**Clearfield Elementary School Renovation & Addition
BG 21-048
Change Order Request
CO 040-02**

DATE:	March 28, 2022	PR #:	07
TO:	Packs + Walker Construction Co. 75 Baldrige Road Morehead, KY 40351	RE:	Clearfield Elementary Renovations & Additions Rowan County, Kentucky BG 21-048 RTA 2037

DATE:	May 19, 2022	PR #:	12
TO:	Packs + Walker Construction Co. 75 Baldrige Road Morehead, KY 40351	RE:	Clearfield Elementary Renovations & Additions Rowan County, Kentucky BG 21-048 RTA 2037

PR 12.1

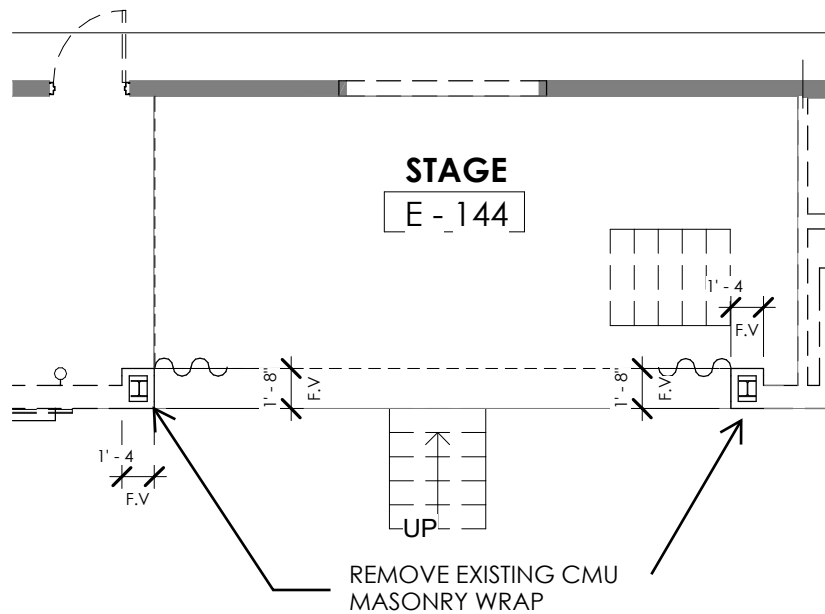
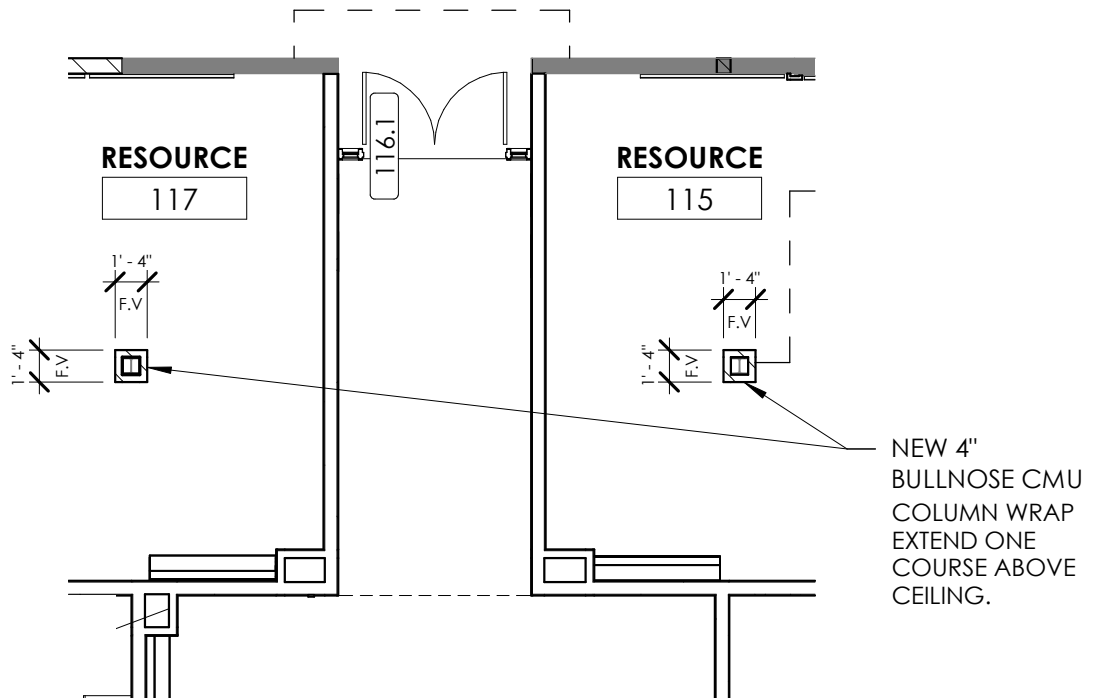
Pr #12 : detailed pricing breakdown for replacing the existing proscenium stage's cmu wrap around the existing steel structure. 2 columns
To lay this back takes 4 CMU and scaffold all the way around the column versus toothing back in 1 CMU and setting up 1 scaffold buck. We now have extra scaffold, a full time saw person because 90 blocks have to be cut versus 30 blocks. Double the scaffold boards, more mortar.

Provide a detailed pricing breakdown for all labor, material, and equipment costs associated with replacing the existing proscenium stage's CMU wrap around the existing steel structure as shown on the attached sketches.

- Structural steel frame to remain.
- CMU removal shall be at no cost due to the drawings C/D1.1 and E/D1.1 showing the original intent for these CMU wraps were to remain in place.
- New CMU wrap shall extend a course above ceiling.
